**Re: Major Projects – New Request for Advice - Yennora Liquid Waste Treatment Plant (SSD-10407)**

Please find below comments from Cumberland Council below:

A Scoping Report has been prepared by Benbow Environmental (report reference - 191251\_Scoping\_Rev4, dated November 2019). The Consultant has advised the following:

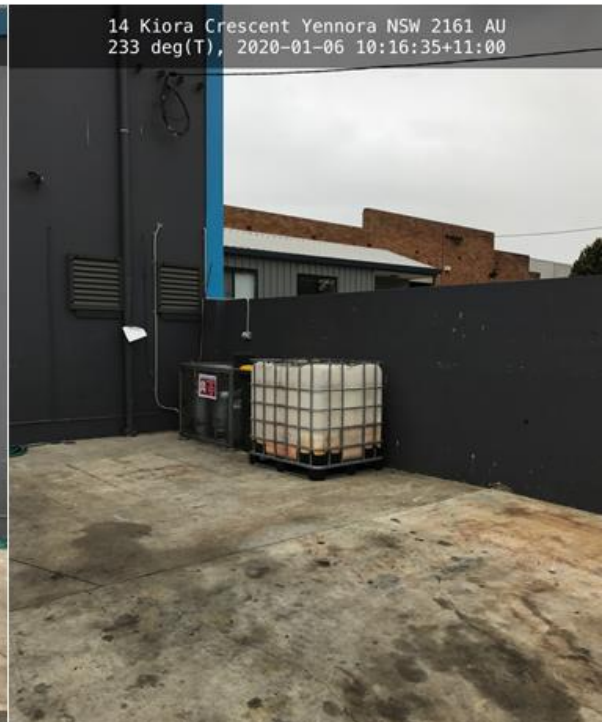
At the time of the inspection, all activities pertaining to waste disposal were carried out inside a shed at the premises. The site consisted of a large shed (where all equipment used to filter and dispose of liquid waste was located) and a concrete hardstand.

Odours, dust, waste, excessive noise was not observed at the road at the time of the inspection. Upon entering the premises, there was a strong odour present as well as noise from vehicles and machinery in use at the time.

It should be noted that an additional property across the road located at 5 Kiora Crescent Yennora (Lot 10/DP 1233715) was used to store IBC's (large plastic containers) some of which were empty although some of which contained some oils and other products used to service their trucks. The operations manager advised that this area was also used to park and service the business's vehicles as needed. The site consisted of some sealed areas however there were also some unsealed areas which were used to park vehicles. This site is also leased out to two other companies. EHU advises that this site be assessed as a part of the application.
